MaxLatency Contribution

Contribution to IEEE 802.1Qdj

Astrit Ademaj, Juergen Wohlmuth

December 14, 2020

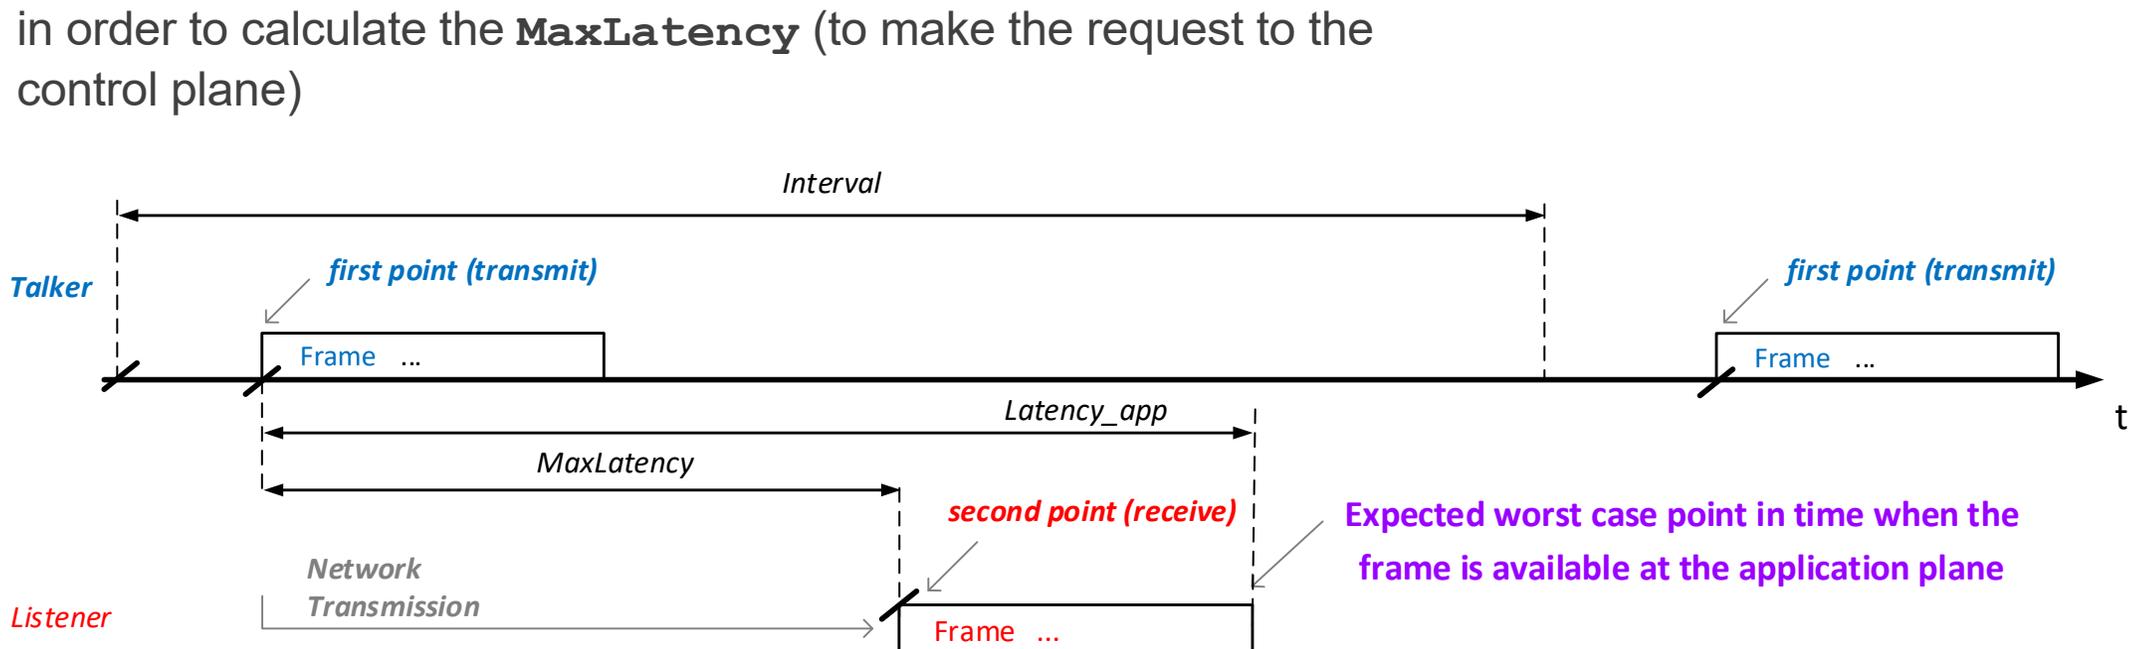
- When specifying a Latency requirements at the listener, from the user/application point of view – it specifies the time where the frame is available to the application layer/plane (**Latency_app**)
- With the current **MaxLatency** definition, the listener needs to consider
 - i) *the maximum frame length*, and
 - ii) *the links speed*

Example: 100Mbit/s link and frame size 1522

Latency_App = 1000µs

MaxLatency = 1000µs – 123µs

Issue 1: "MaxLatency" definition (2)

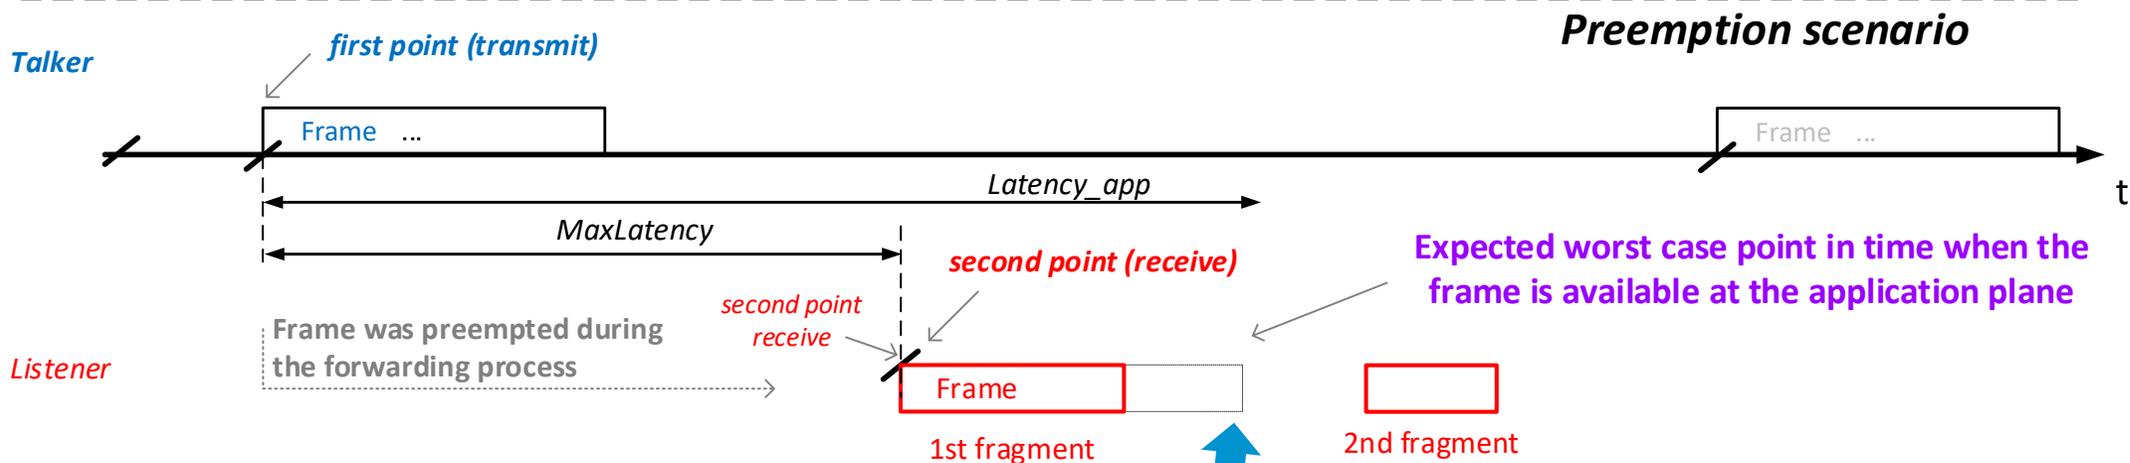
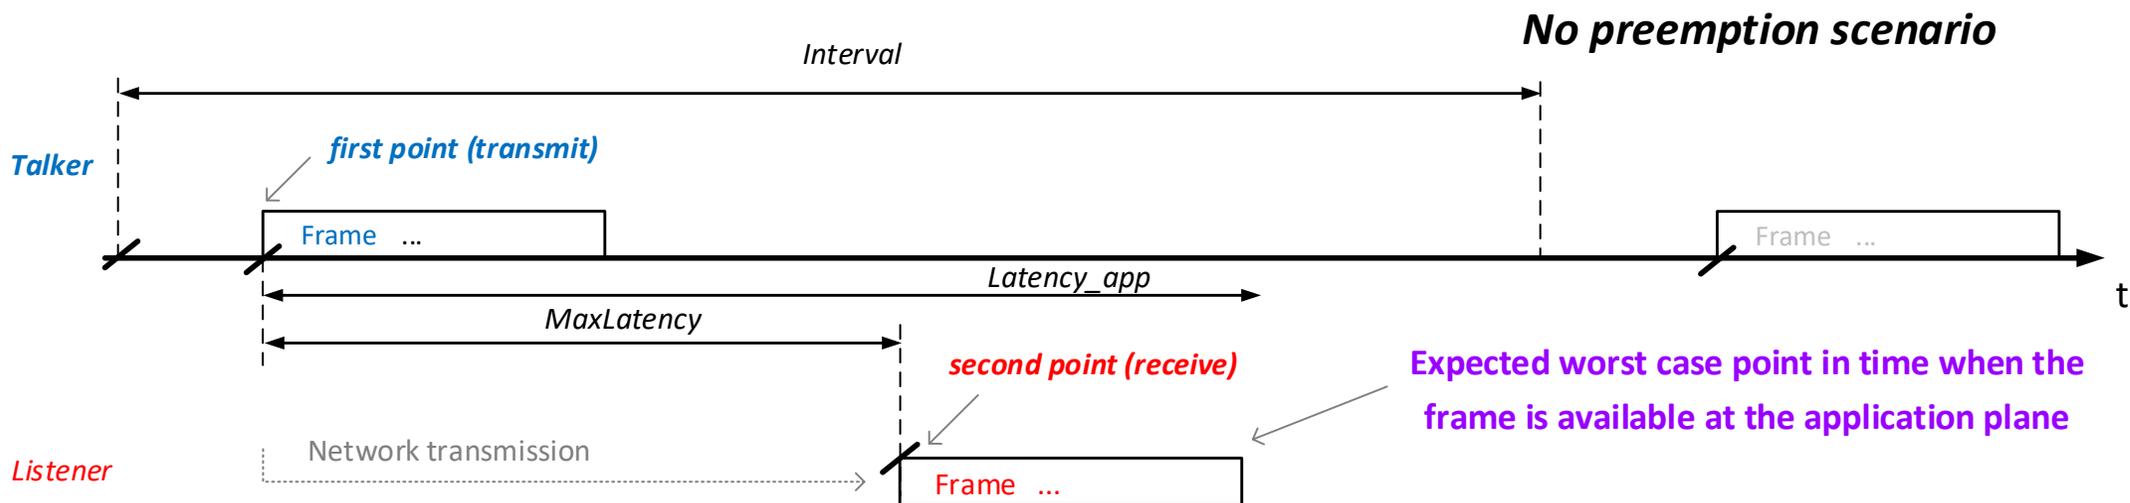
In case of preempted packets, with the actual "MaxLatency" definition, it is not possible for the listener to derive the point in time when the stream's frame is fully received, i.e. the point in time when the internal processing starts

Issue 1: "MaxLatency" definition (3)

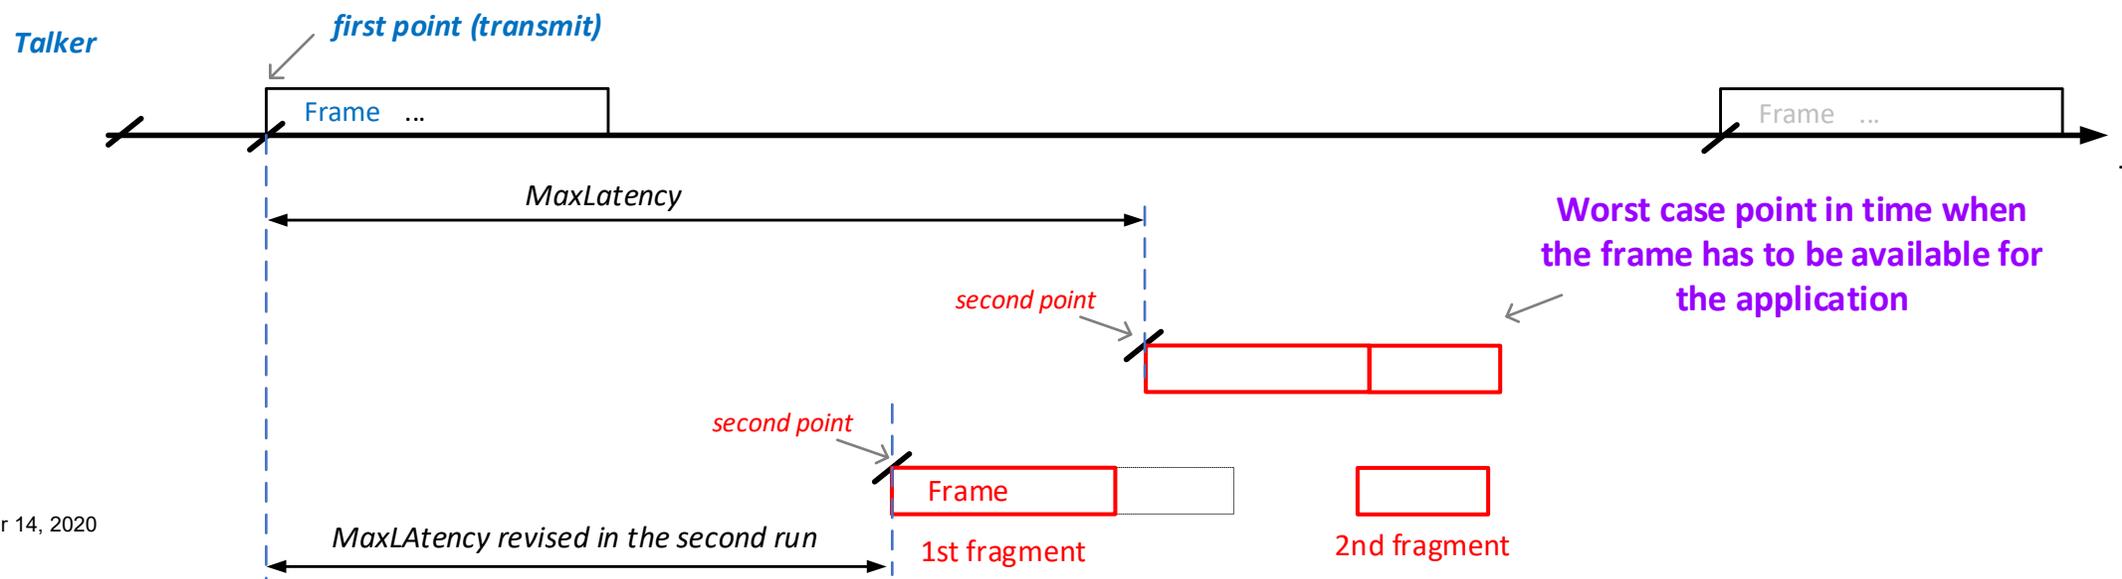
With the current definition of MaxLatency and with preemption activated following "options" are possible:

- a) CNC has to make sure that the preemption does not occur in the last hop (it means disabling preemption to all bridge ports connected to endpoints)
- b) the application must account for the interleaving delay of the preempted fragment when calculating MaxLatency out of Latency_App
- c) to account for the interleaved fragment delay, CNC must recalculate/revise internally the MaxLatency (redefine the second point) after doing the calculations in the first run (feedback loop – see example below)

not practical

not possible as this knowledge is within the CNC and not in the local application)

significant increase of the CNC complexity

Issue 1: "MaxLatency" definition (5)

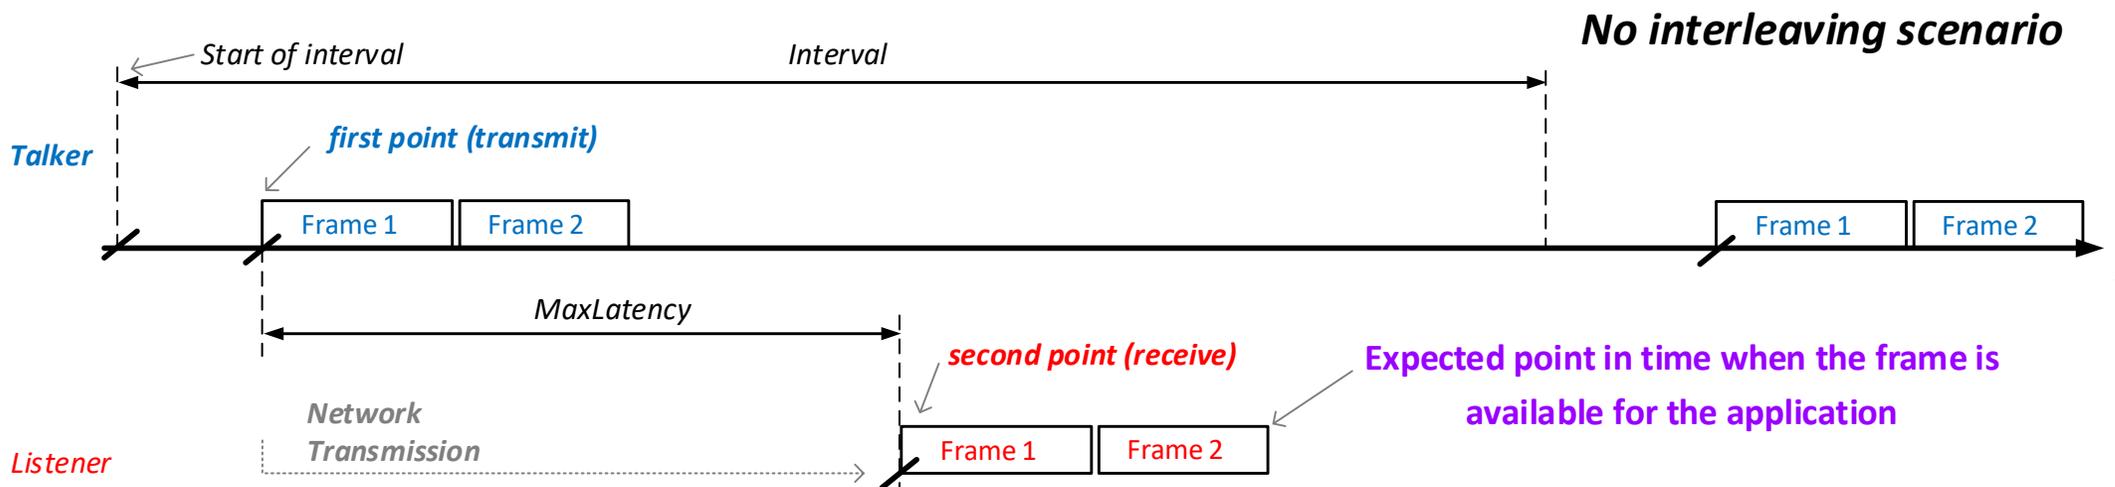
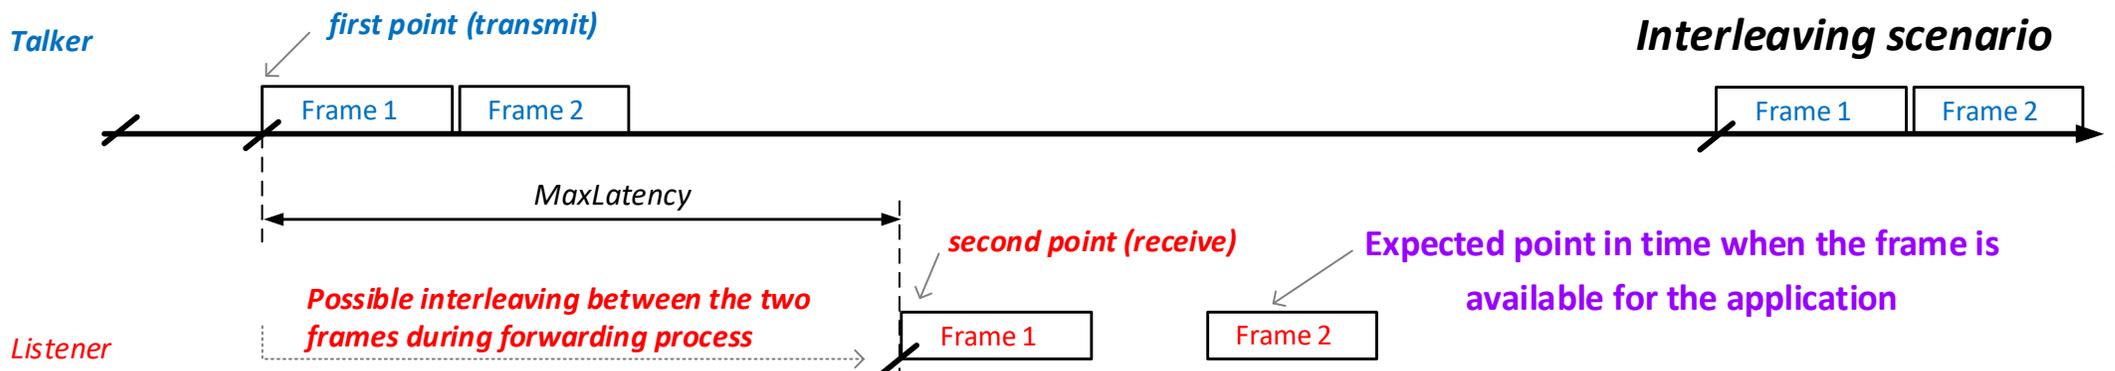
- In case of streams with multiple frames (`max-frames-per-interval > 1`), the listener cannot be aware of possible interleaving frames (latency definition is for the single frame)
- Consequently, it is not possible for the listener to derive the point in time when the stream's packet is fully received, i.e. the point in time when the internal processing starts

Issue 1: "MaxLatency" definition (6)

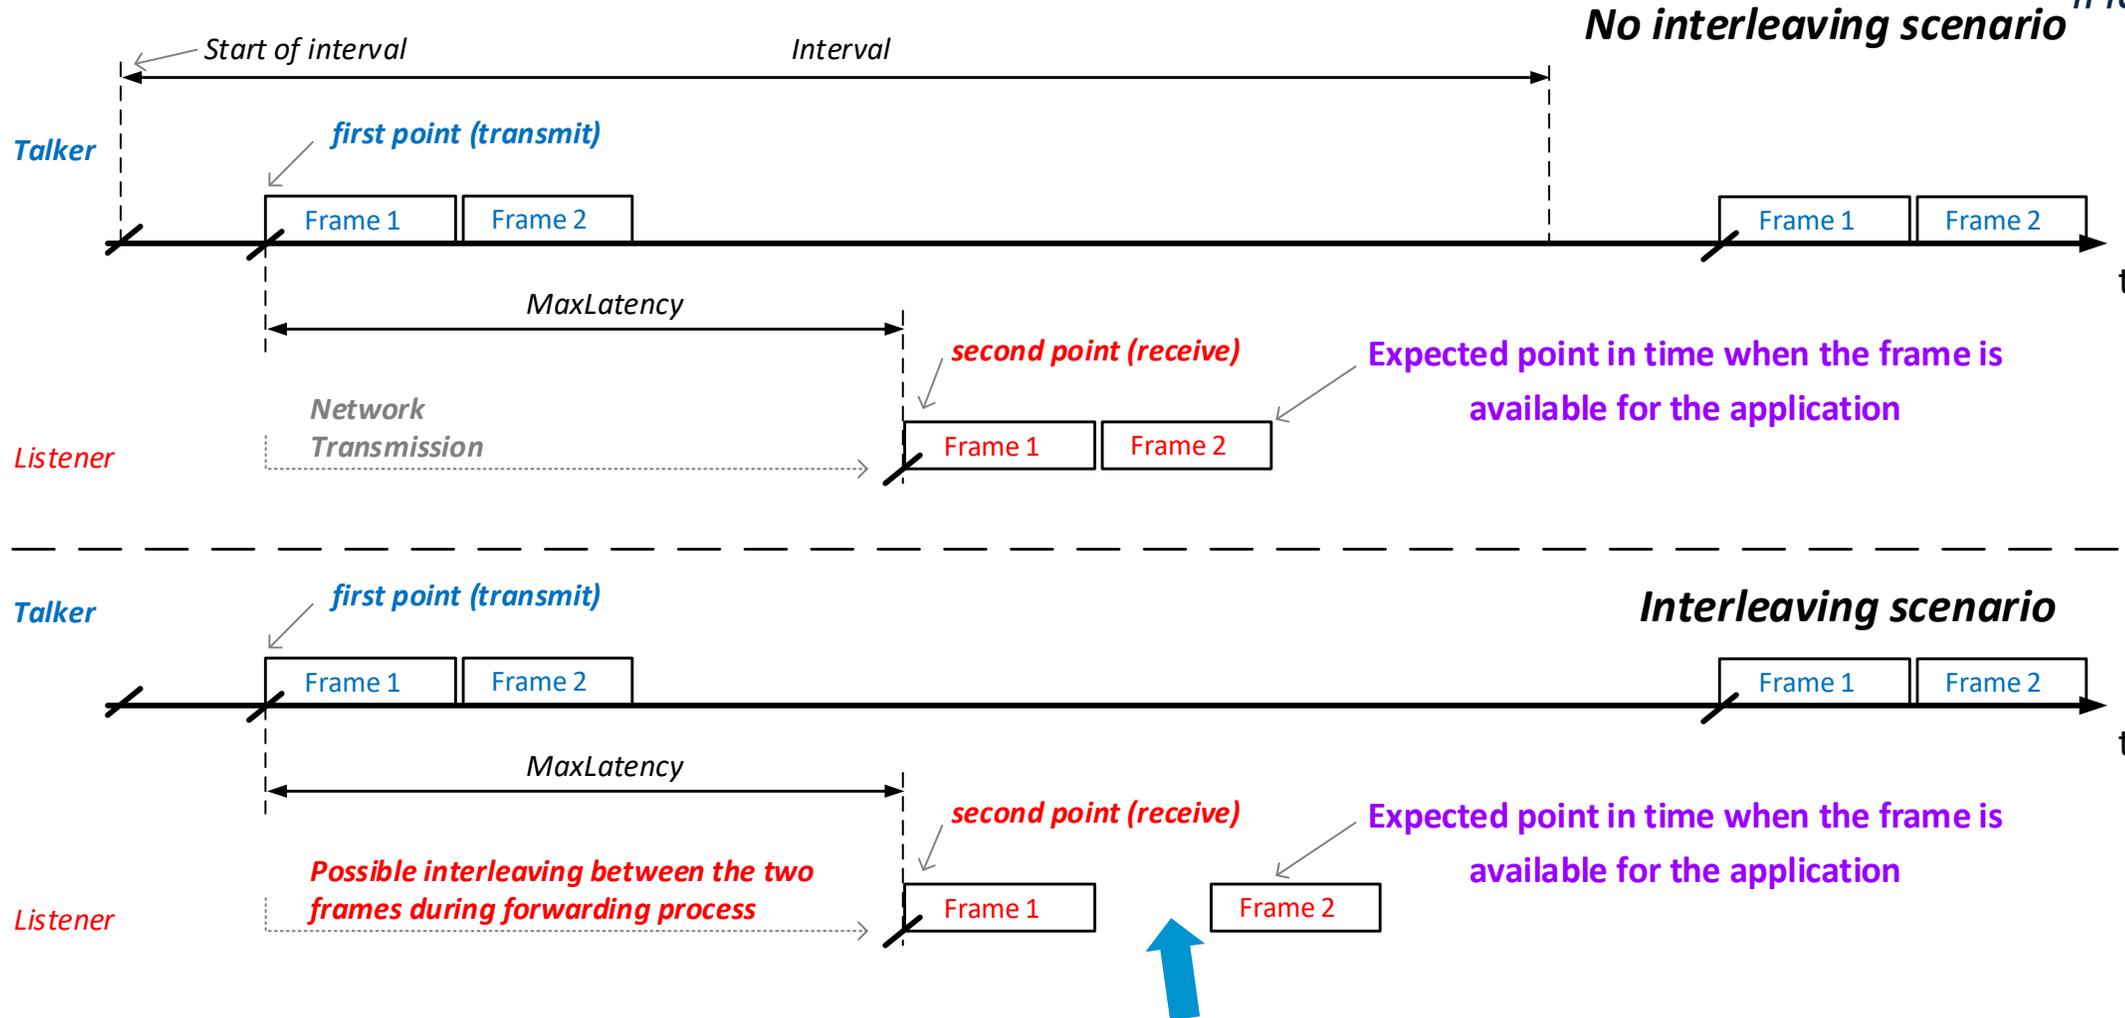
- In case of streams with multiple frames the listener cannot be aware of possible interleaving
- Consequently it is not possible for the listener to derive the point in time when the stream's packet is fully received, i.e. the point in time when the internal processing starts

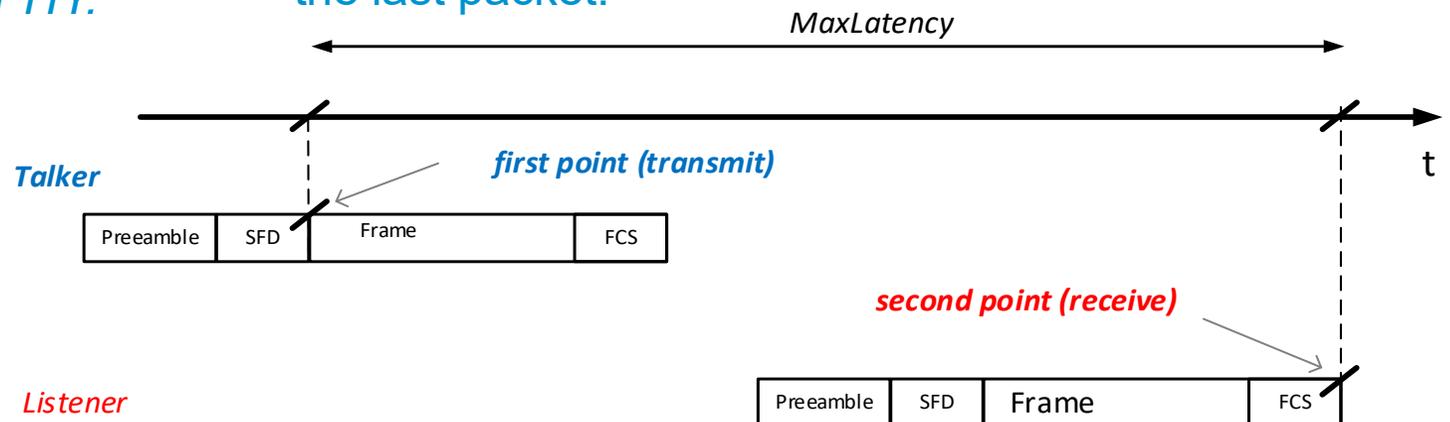
Proposal: change Sect. 46.2.3.6.2 to:

“MaxLatency shall use the definition of 3.118, with additional context as follows: The “known reference point in the frame” is the message timestamp point specified in IEEE Std 802.1AS for various media (i.e., start of the frame) for the “first point”,

and the end of the last symbol of the FCS for the “second point”.

The “first point” is in the Talker at the reference plane marking the boundary between the network media and PHY (see IEEE Std 802.1AS). The “second point” is in the Listener at the reference plane marking the boundary between the network media and PHY.”

The change represents the exact time during which the frame (or parts of it) under the responsibility of the CNC, i.e.,

- from the time the first symbol leaves the talker,
- to the time the last symbol entered the listener, and at which time the listener can start its local processing.

This also applies to fragmented packets (which are possibly interleaved by other frames), since MaxLatency for talkers and listeners are calculated on the last packet.
